MEMORANDUM

To: Ogden Valley Planning Commission
From: Charles Ewert, AICP
Date: June 25, 2018
Subject: Maverik Site Rezone

MAVERIK, INC. STORE #250
5100 EAST & 2500 NORTH
EDEN, UTAH

6/15/18 Maverick General Plan Amendment and Rezone Review:

**PROPOSED
SITE PLAN**

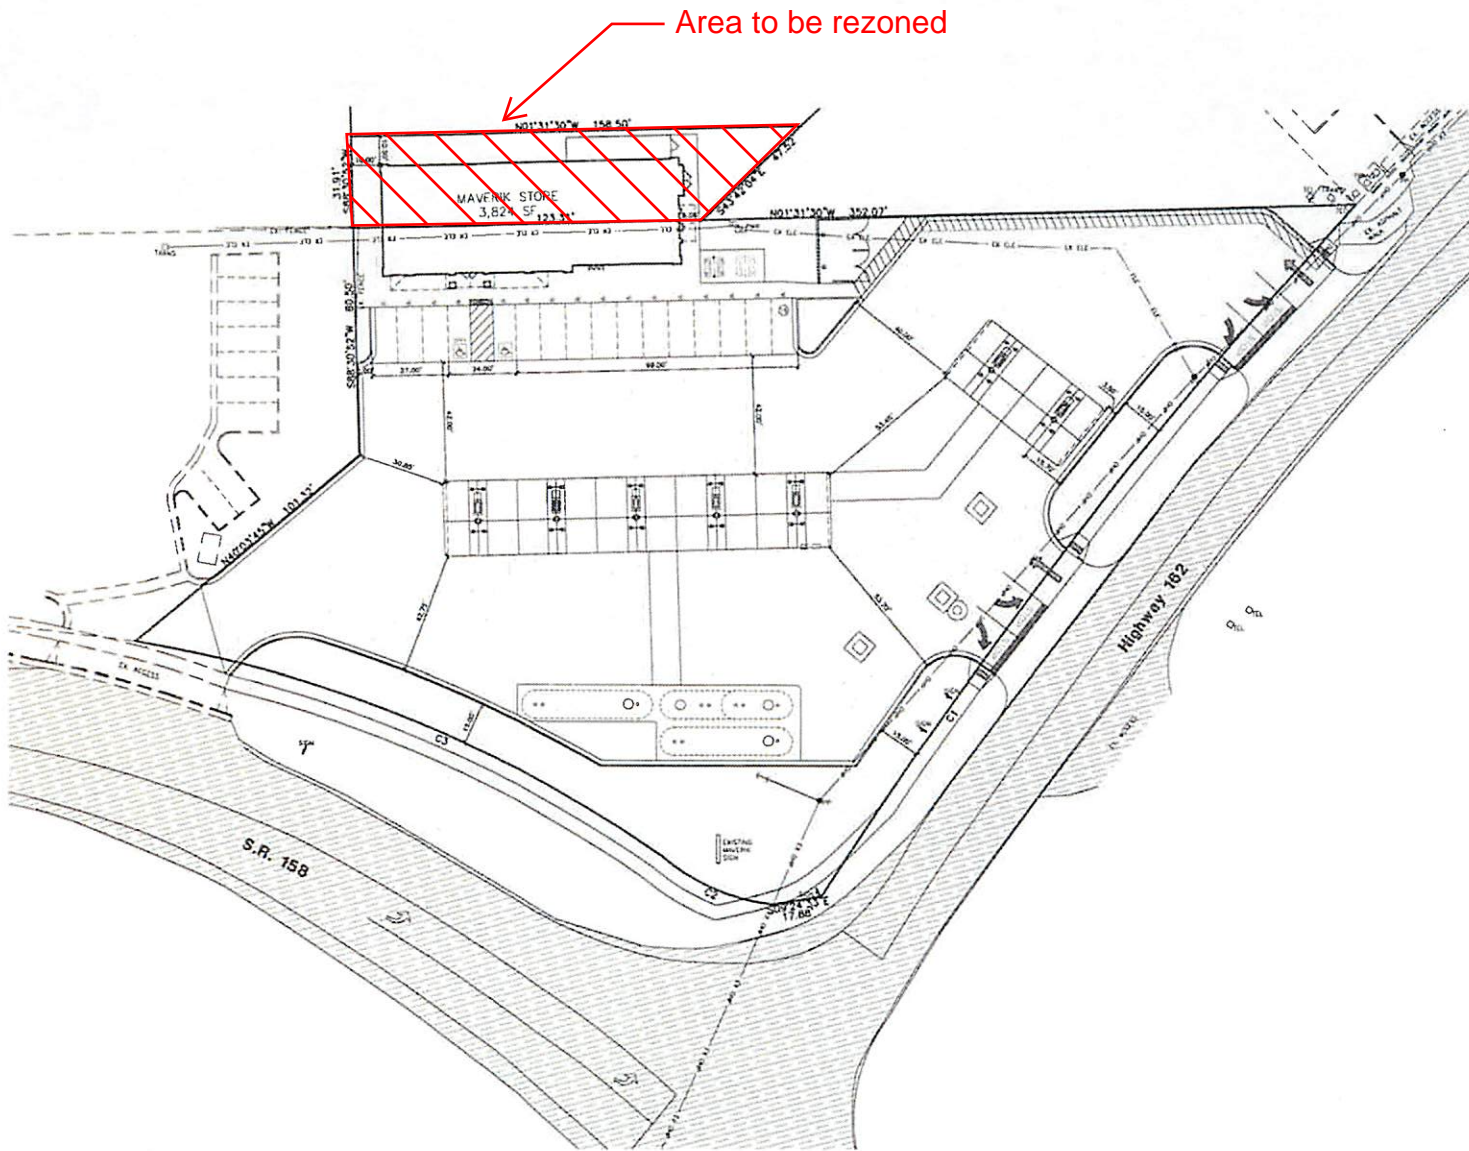
The current layout of this site is considered strip-style development, with the building pushed to the back of the lot and parking/hardsurface in the front. The proposed layout is similar. This development pattern does not create the desired Village effect the plan anticipates.

A more appropriate design for this site would be to bring the proposed building (with all architectural considerations previously specified) up to the street frontage, with street-facing retail windows and entrance. We would not discourage another entrance or exit on a non-street side that fronts a gas canopy. In bringing the building up to the street it should be positioned such that other buildings with street-facing retail windows and a zero setback from this building could be established at some point in the future. The street frontage should be improved with curb, gutter, and street trees, along with a sidewalk of sufficient width to safely accommodate future village patrons. If you desire support from staff for this rezone, please reconfigure the site to accommodate this general-plan direction.

I understand the reason you desire to push the building back is due to site area given existing development regulations. Bringing it to the front lot line would offer the same effect on site area. Also, we are more than happy to discuss altering other more strenuous requirements if you choose to negotiate the location of the building with us, provided the overall effect is supported by the general plan.

PERSPECTIVE

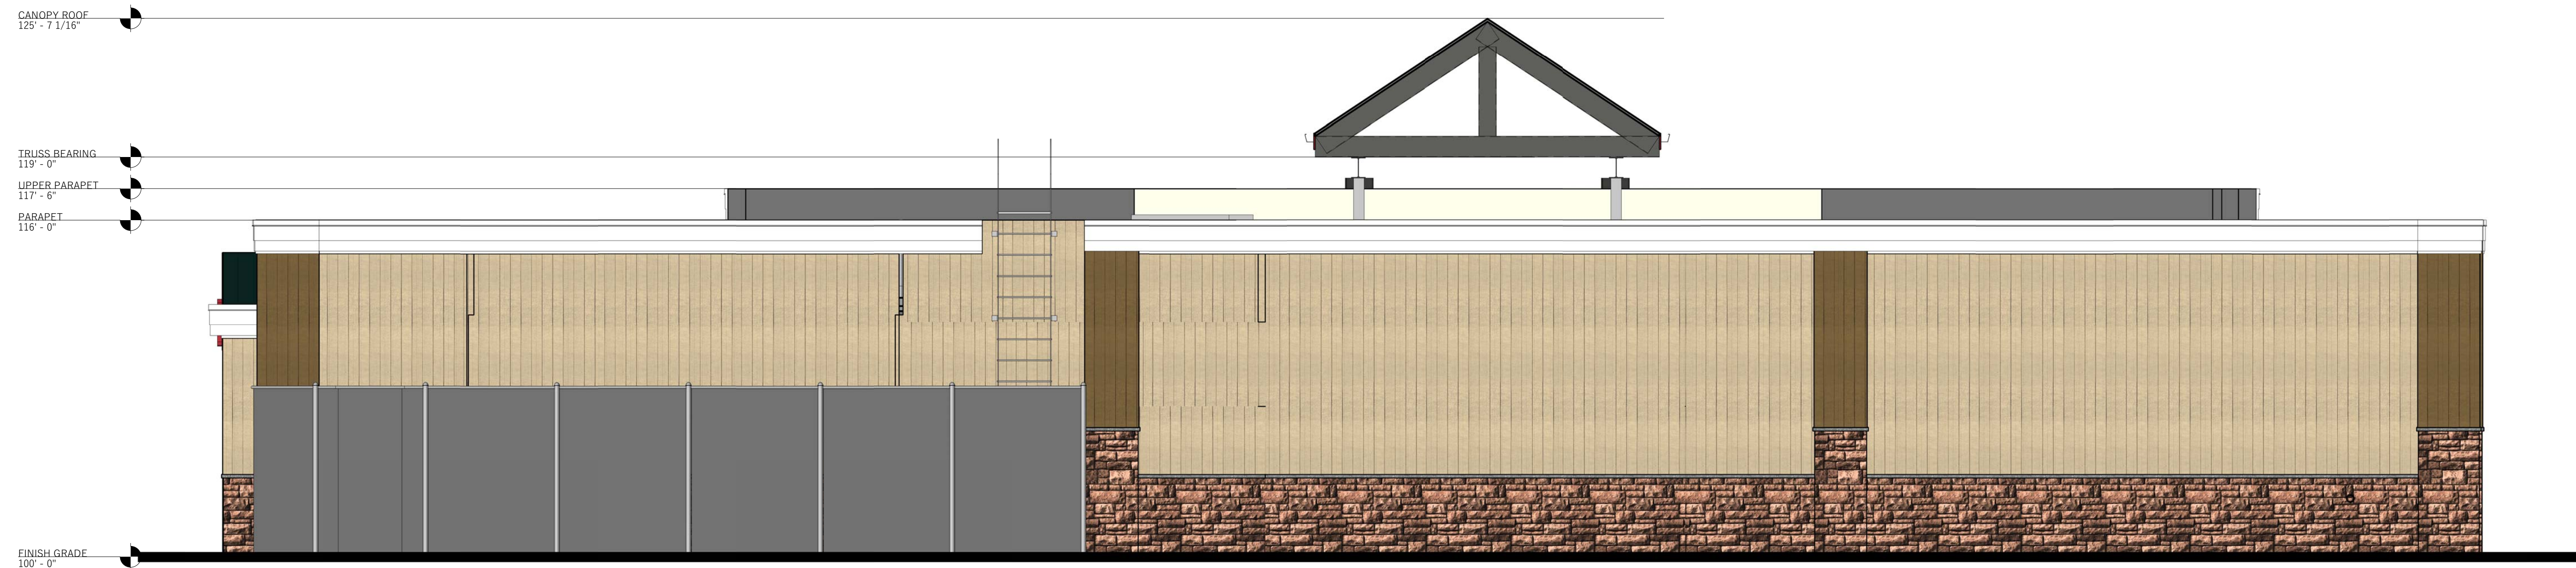
Regarding the architectural rendering, the general plan offers significant direction on how to design a structure in compliance with desired architectural standards. Specifically:

- General plan implementation 1.1.3 suggests that all new commercial buildings be architecturally and visually compatible with neighboring historic properties. Please supply building renderings that considers similar architectural styling as other historic buildings in the area. The following figure is offered on page 26 of the plan:

Please note that "Mountain Rustic" would not be appropriate for this site. I think the style that will get you the most traction on a rezone is to commit to a type of old west mine or similar, as can be found down the road surround the Eden Park. The better it celebrates historic buildings the more likely the rezone will be.

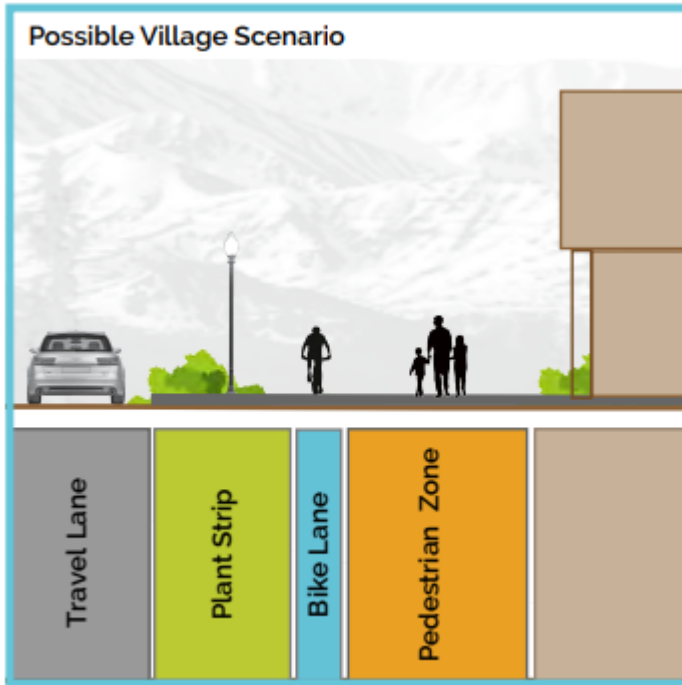
- Commercial Development Principle 1.1 of the general plan says to “**avoid scattered and strip commercial** and retail development patterns in the Valley.”
- Commercial Development Implementation 1.1.2 further explains that we should “**avoid rezoning new property to commercial or manufacturing until such time that the community supports it.** Future commercial or mixed-use rezoning should only be considered adjacent to existing commercial or mixed-use zoning in a manner that creates village clusters and **avoids strip commercial along highway corridors.**
- Streetscape Design Implementation 1.1.1 says to “develop and adopt multimodal streetscape cross sections for villages based on the small area plans referenced in Commercial Development Goal 1. The plan also includes a cross section example:

Even though specific small area/village planning is still in progress, including street cross sections, the general plan offers sufficient information on how to get there in its absence. As the center of the future Eden Village, this is an important corner. Any modifications to the site (that is not otherwise entitled by existing law) should be configured to enhance the small-village future specified in the general plan.

Reno, NV.

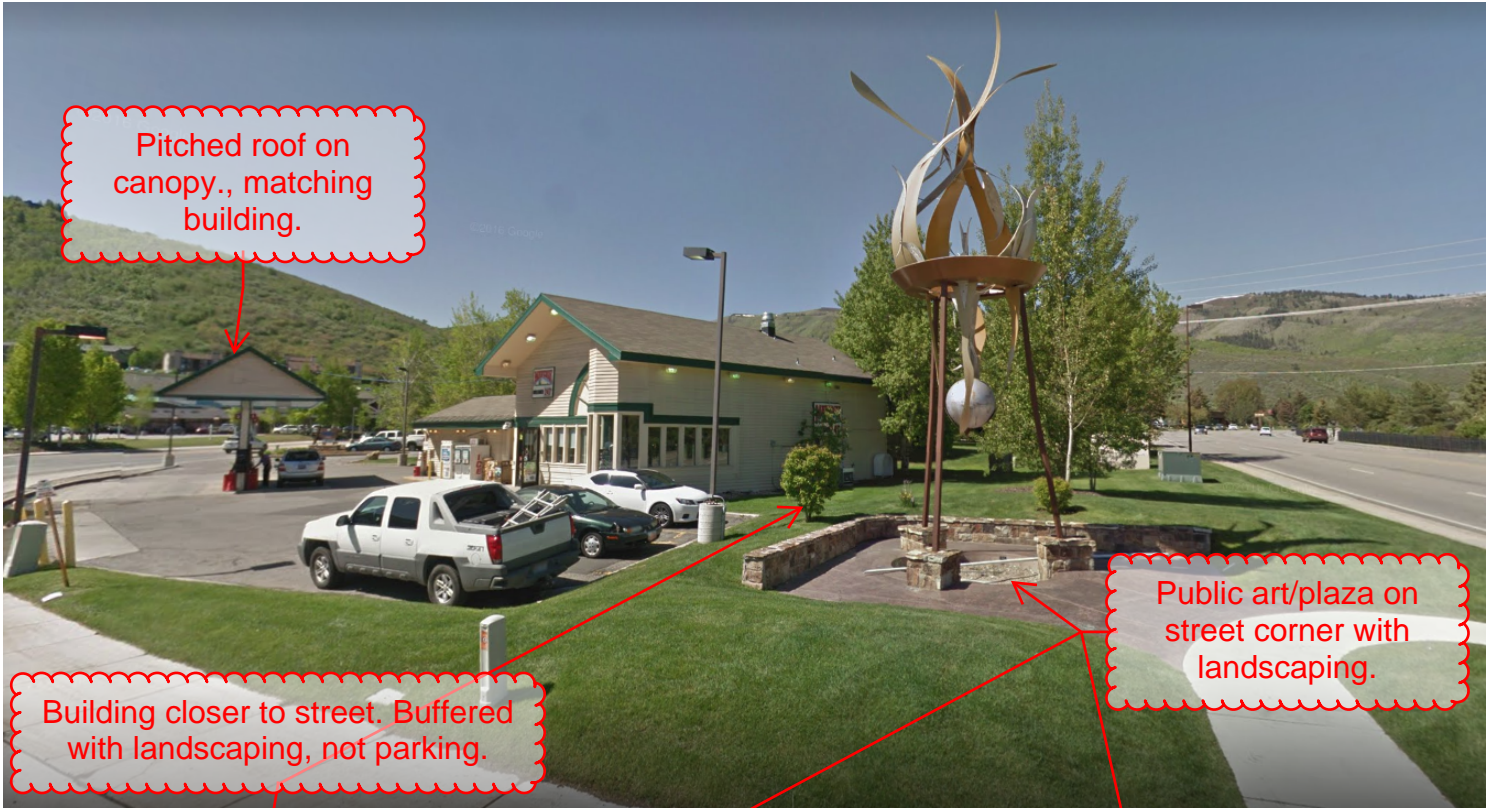
Partial pitched roof canopy with shingles consistent with local architectural theming.
